AGENDA
Historic Yorktown Design Committee

MEMORANDUM

SUBJECT: Application No. HYDC-270-25, Kori L Brewer & Gilbert K Jones, New Single-Family Attached Dwelling, 101 Chischiak Watch

PLOT PLAN OF
 LOT 1, SECTION ONE
 CHISCHIAK WATCH
 FOR
 WAYNE HARBIN BUILDERS LLC
 YORK COUNTY VIRGINIA

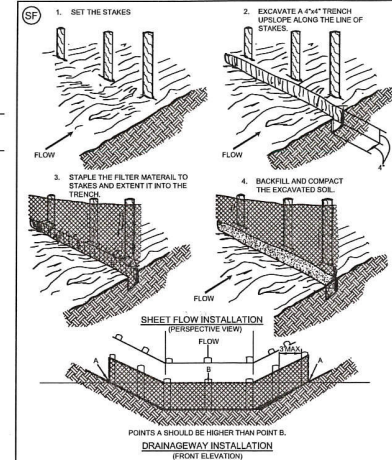
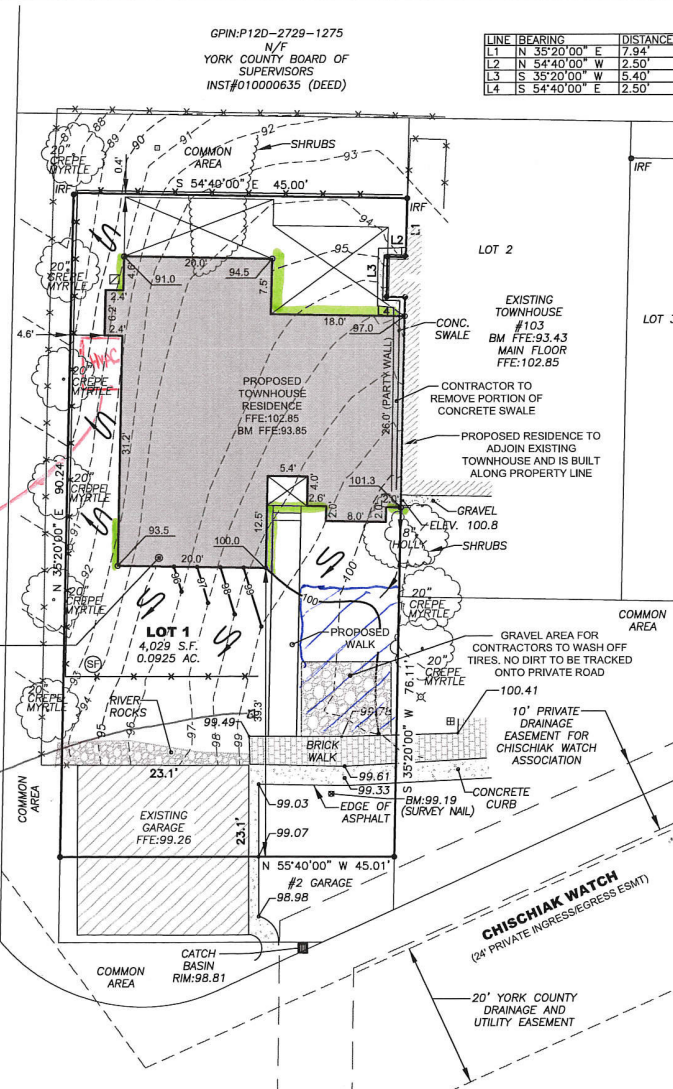
A proposed HVAC unit would be located in the side yard and enclosed by a white picket-style fence. The Guidelines recommend using evergreen screening, a solid fence, or a combination of the two. A condition has been included that would require the fence to be solid, similar to other Chischiak HVAC unit fences.

2. The HVAC unit shall be screened from view with a white wooden *solid* fence.
3. Trashcans shall be kept either inside the garage or a space screened from view by a solid fence or evergreen plantings of a species type that retains branching to ground level.
